**RESPONSE TO SUBMISSIONS REPORT
NEPEAN HOSPITAL STAGE 2 REDEVELOPMENT
SSD DA 16928008**

PART A – MAIN REPORT

RESPONSE TO SUBMISSIONS REPORT PART A – MAIN REPORT

SSD DA 16928008 NEPEAN HOSPITAL STAGE 2 REDEVELOPMENT DERBY STREET, KINGSWOOD

Figure 1 - Extract of Softworks Plan – PLN-0000401 Issue B – relevant trees circled in blue (Arcadia)

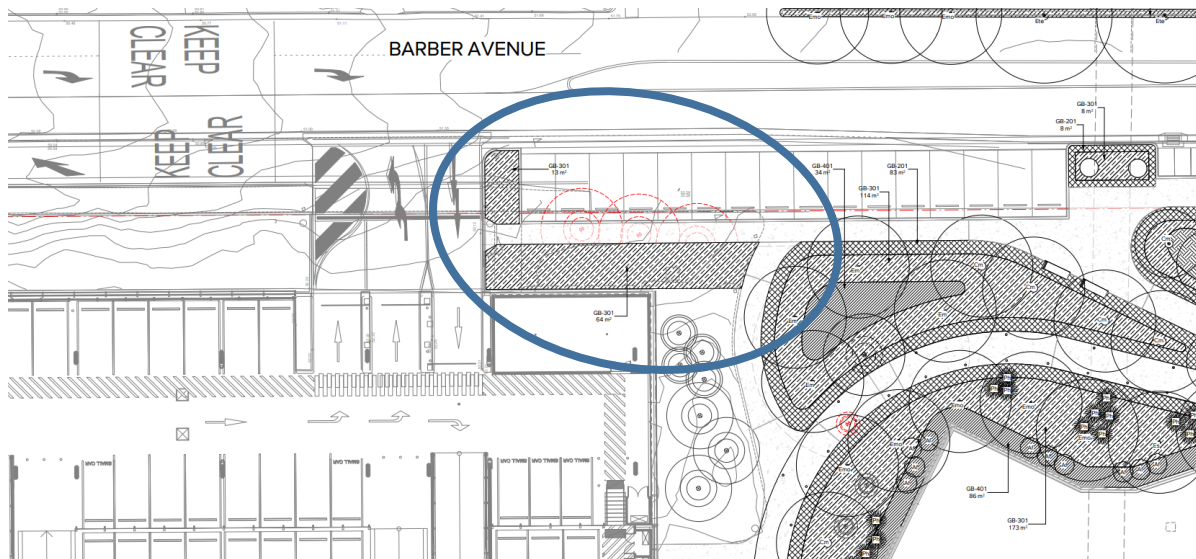
Based on Arcadia's plans, three (3) additional existing trees are lost as a result of the Barber Avenue changes to reinstate parking. These occur as shown in the figure below and are within the hospital's boundary towards the existing entry/exit to the multi-storey car park. These trees were not previously identified by Moore Trees in the Arboricultural Development Assessment Report as lodged, however relevantly, these are not remnant nor significant trees, being part of the landscaping works associated with the new multi-storey car park and since removed for other works in 2021 and replaced with two (2) trees in 2021/2022 – see figures over the page from May 2021 and 24 May 2022.

To cater for the reinstatement of parking and the realigned footpath, these two trees will need to be removed or transplanted.
